JINDAL ALUMINIUM LTD.
BANGALORE-560073 (INDIA)

NAME	DATE
DRAWN	PARVESH	21-10-2013
CHECKED		
APPROVED	S.S.GARG	21-10-2013
SCALE		0.5:1
AREA mm ²		1909.063
PERIMETER mm.		530.113
WEIGHT kg/m		5.154
DRAWING No.		SECTION No.
P-12312		-
10427		10427(ISSUE-4)

PARTY'S NAME	BANGALORE MARKET (ROLLING MILL DIVISION)
PARTY'S DRAWING No.	AS PER SPECIFICATION
ALLOY & TEMPER	19700
DESCRIPTION	FLAT BAR

P-12312

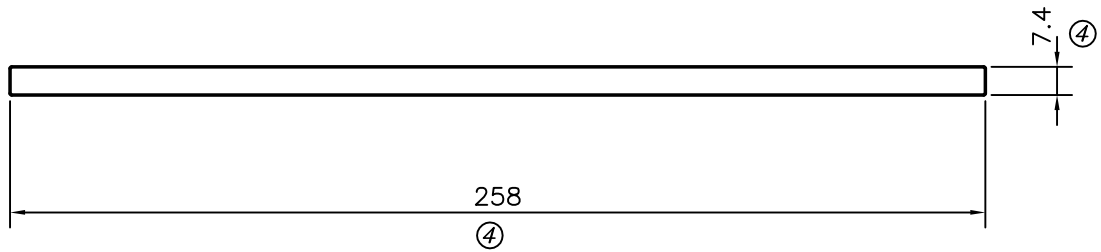
- ☞ TOLERANCE ADDED ON THICKNESS.

- ☞ THICKNESS CHANGED FROM 5.9 TO 9 mm.
- ☞ WEIGHT ALSO CHANGED FROM 4.094 Kg/M. TO 6.245 Kg/M.

- ☞ THICKNESS CHANGED FROM 9.0 TO 7.4 mm.
- ☞ DIMENSION CHANGED FROM 257 TO 258 mm.
- ☞ WEIGHT ALSO CHANGED FROM 6.245 Kg/M. TO 5.154 Kg/M.
